Grading Plan
Scale: 1"=30'

Popeyes Chicken & Biscuits Restaurant
JUAN TABO NE AT LEXINGTON AVENUE NE, ALBUQUERQUE, NEW MEXICO

SHEET NO.
C.2

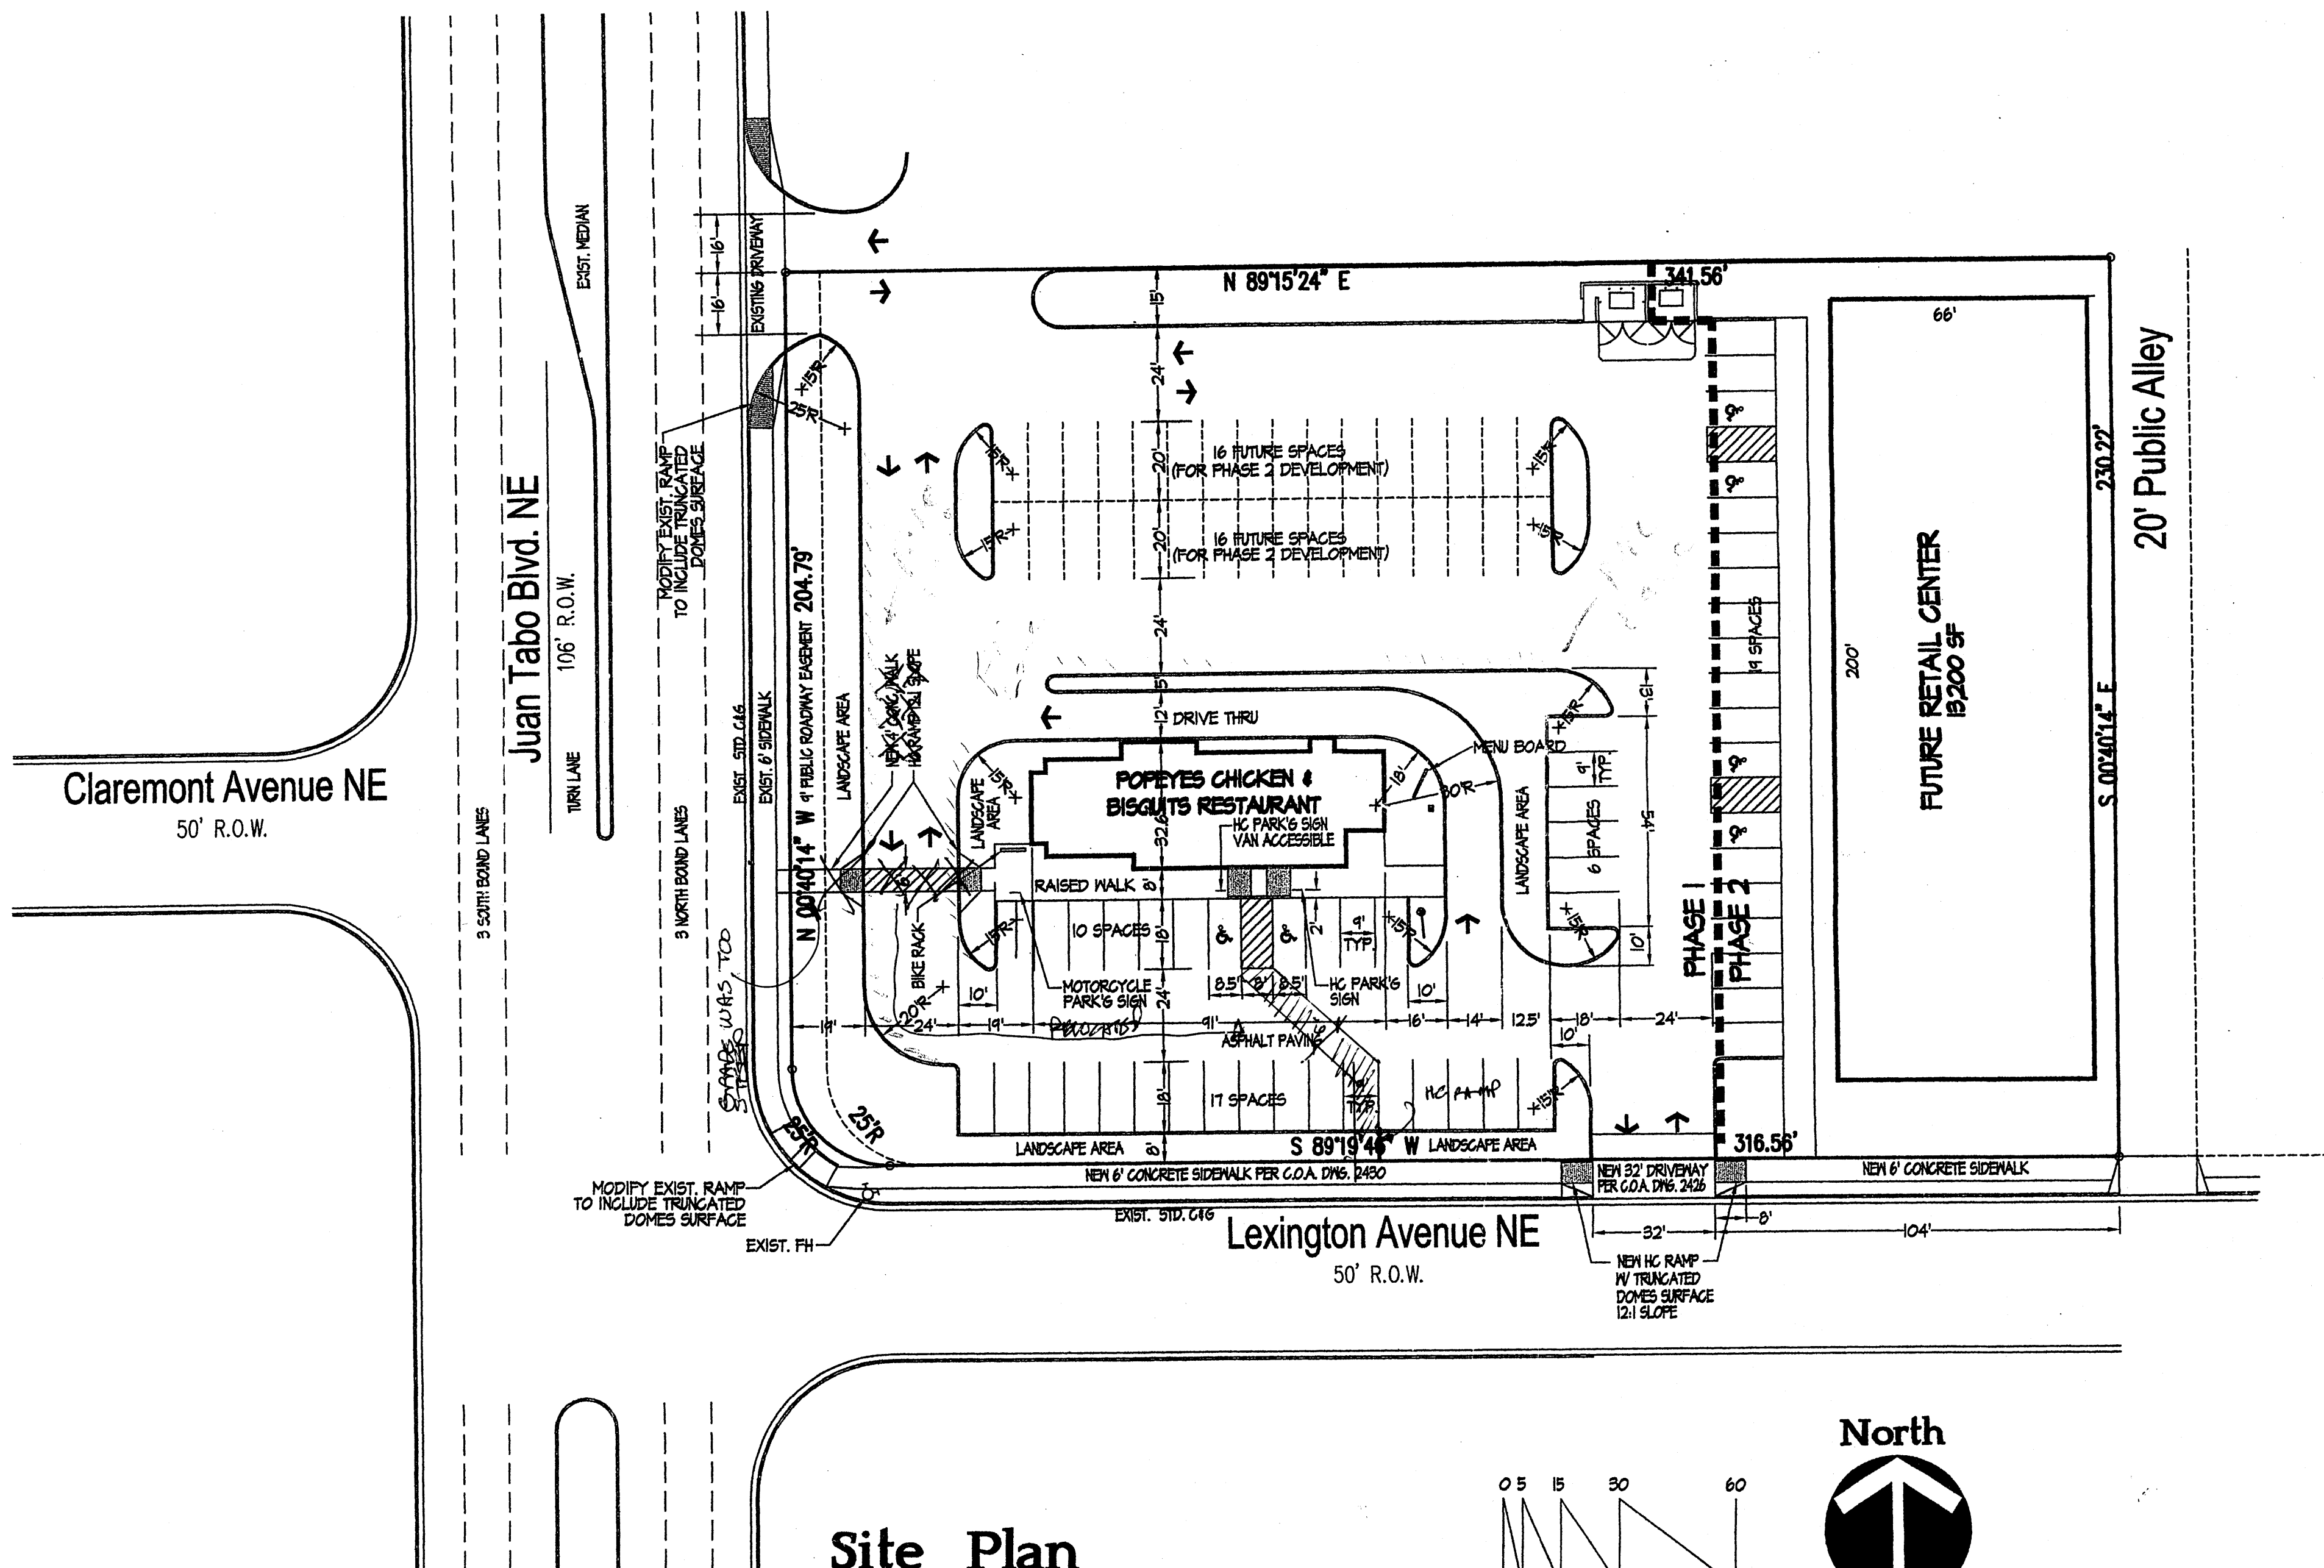
I, JEAN J. BORDENAVE, NMPE&LS NO. 5110, OF THE FIRM BORDENAVE DESIGNS, HEREBY CERTIFY THAT THIS PROJECT HAS BEEN GRADED AND WILL DRAIN IN SUBSTANTIAL COMPLIANCE WITH AND IN ACCORDANCE WITH THE DESIGN INTENT OF THE APPROVED PLAN DATED OCTOBER 04, 2006. THE RECORD INFORMATION EDITED ONTO THE ORIGINAL DESIGN DOCUMENT HAS BEEN OBTAINED BY ME OR UNDER MY DIRECT SUPERVISION AND IS TRUE AND CORRECT TO THE BEST OF MY KNOWLEDGE AND BELIEF. THIS CERTIFICATION IS SUBMITTED IN SUPPORT OF A REQUEST FOR CERTIFICATE OF OCCUPANCY. THE RECORD INFORMATION PRESENTED ON THE EDITED DESIGN DOCUMENT IS NOT NECESSARILY COMPLETE AND IS INTENDED ONLY TO VERIFY SUBSTANTIAL COMPLIANCE OF THE GRADING AND DRAINAGE ASPECTS OF THIS PROJECT. THOSE RELYING ON THE EDITED DESIGN DOCUMENT ARE ADVISED TO OBTAIN INDEPENDENT VERIFICATION OF ITS ACCURACY BEFORE USING IT FOR ANY OTHER PURPOSE.

SHEET NO.
C.1

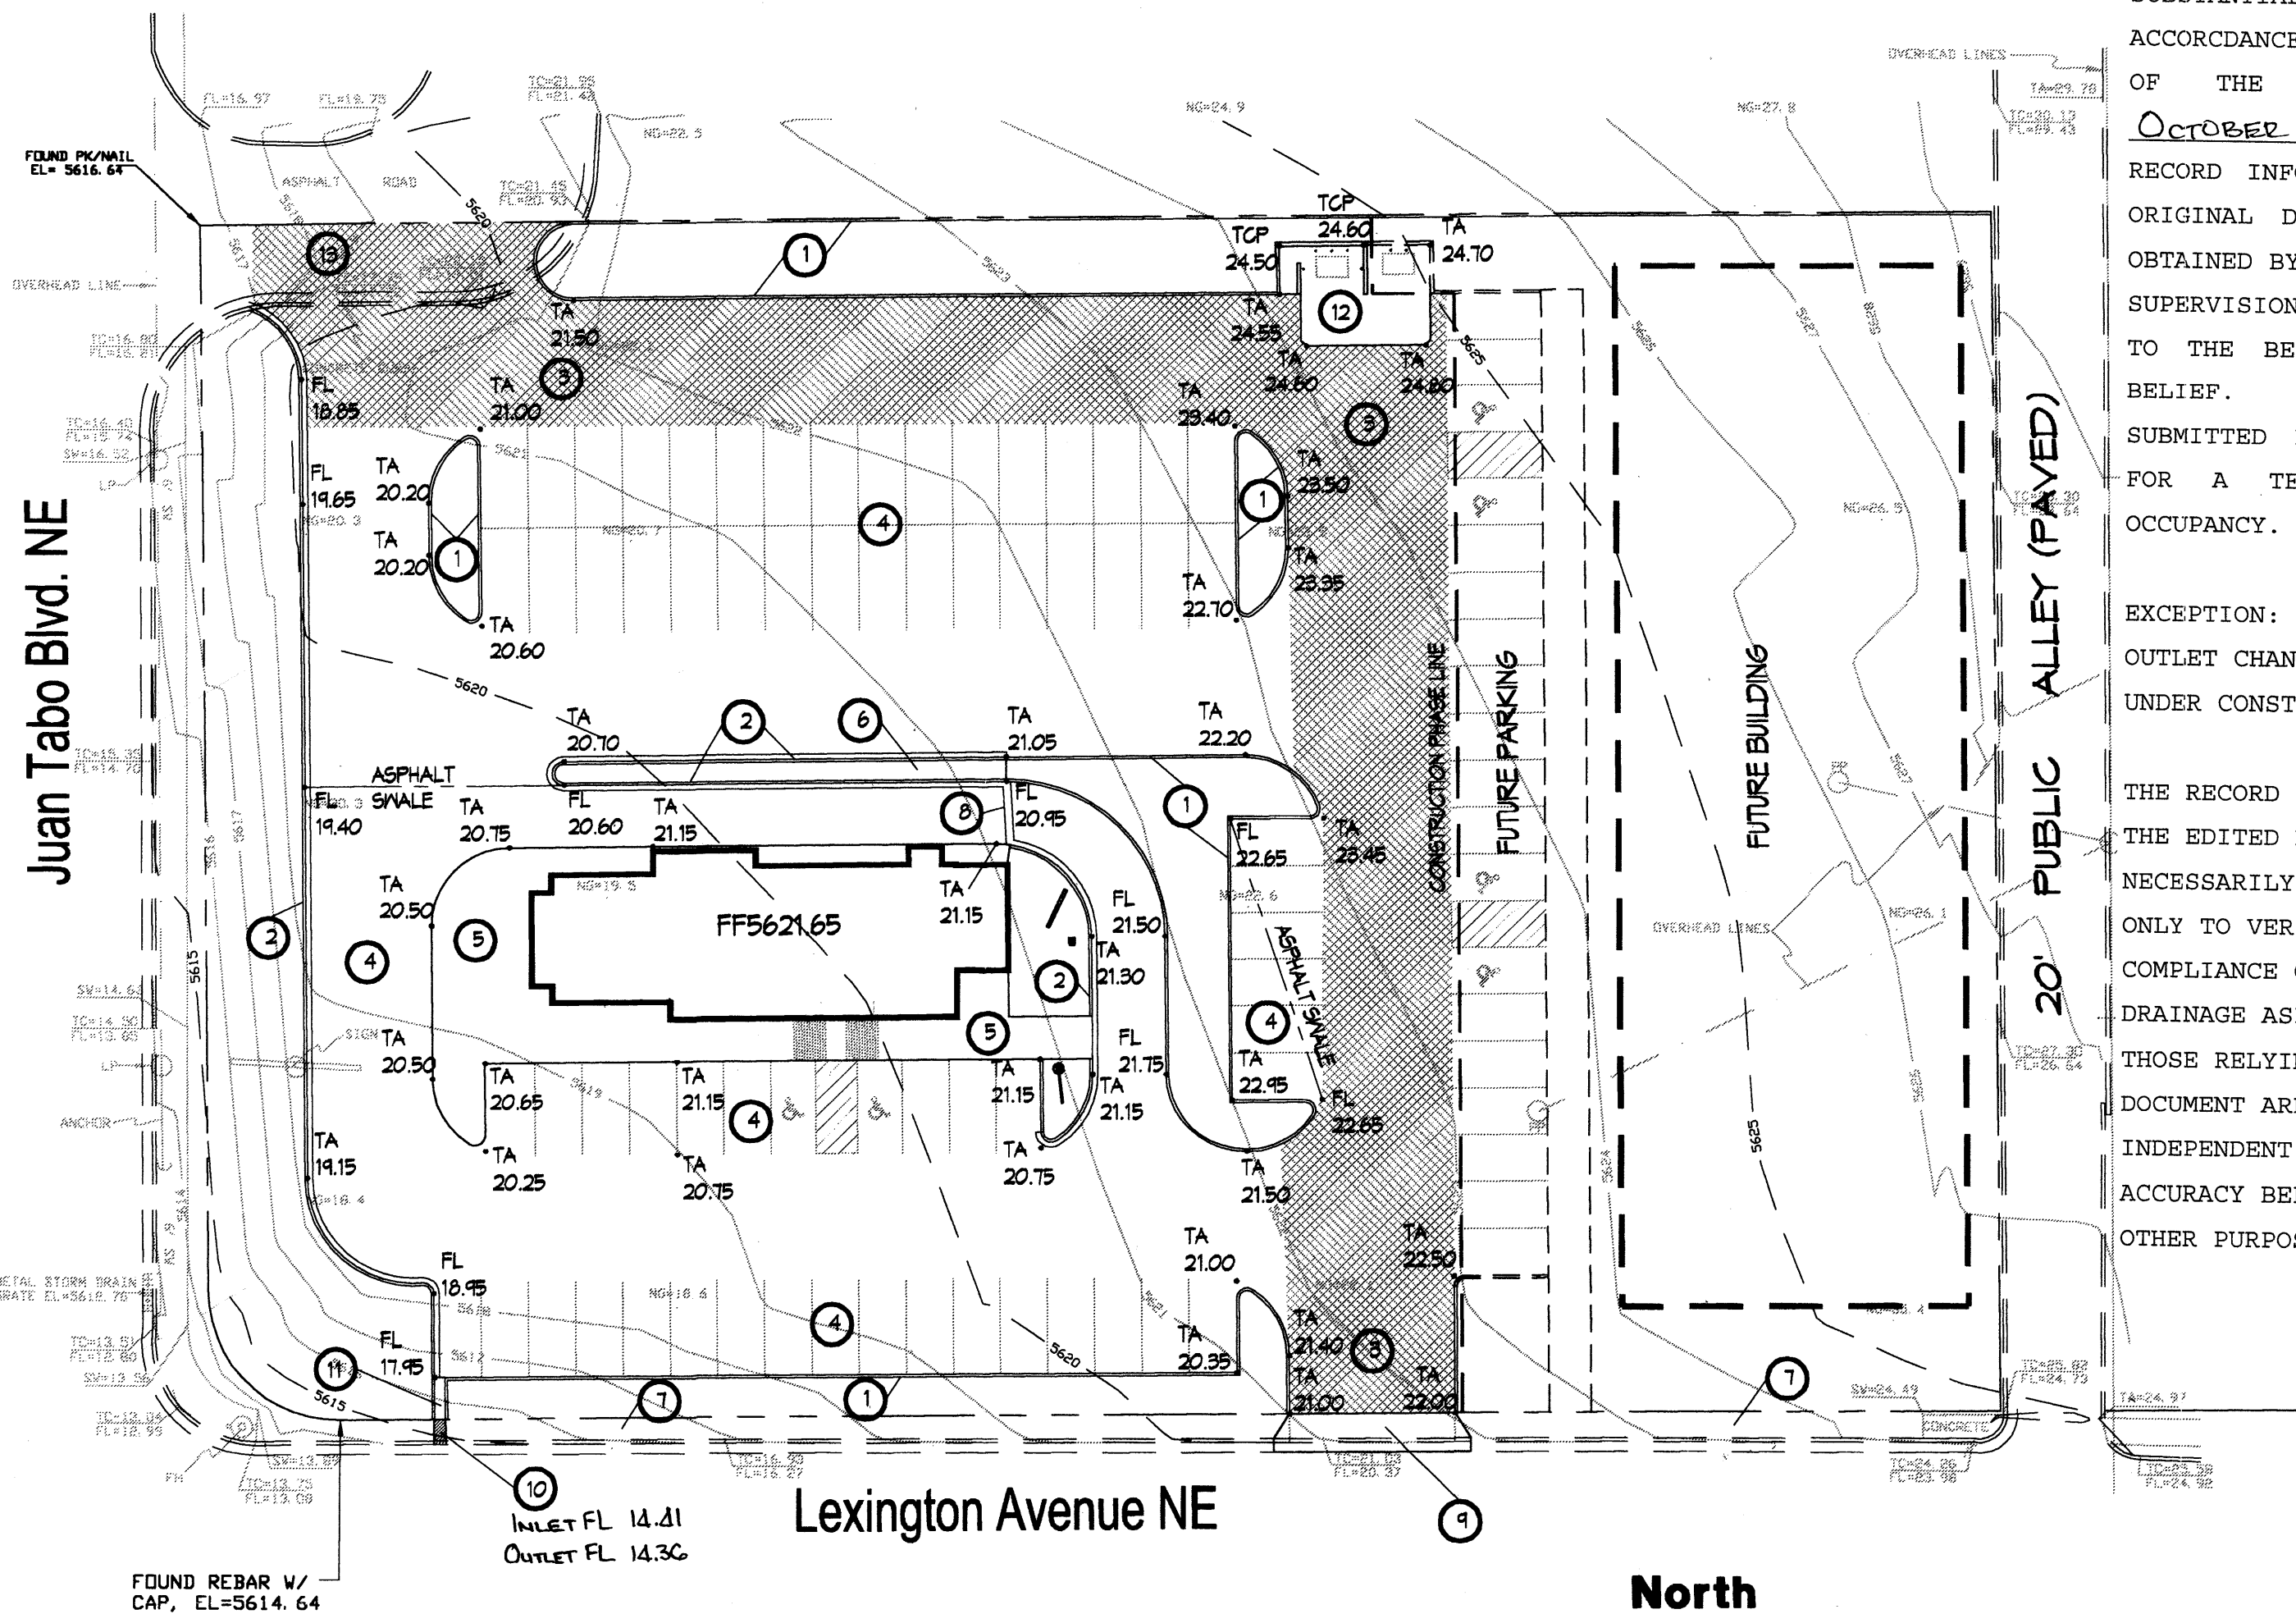
EXEMPTIONS AS INDICATED IN RED INK, PEDESTRIAN ALLOYS
WAS RELOCATED BECAUSE GRADE WAS WAY TOO STEEP WHERE
SHOWN ORIGINALLY. KEN HOVEY
6-28-07
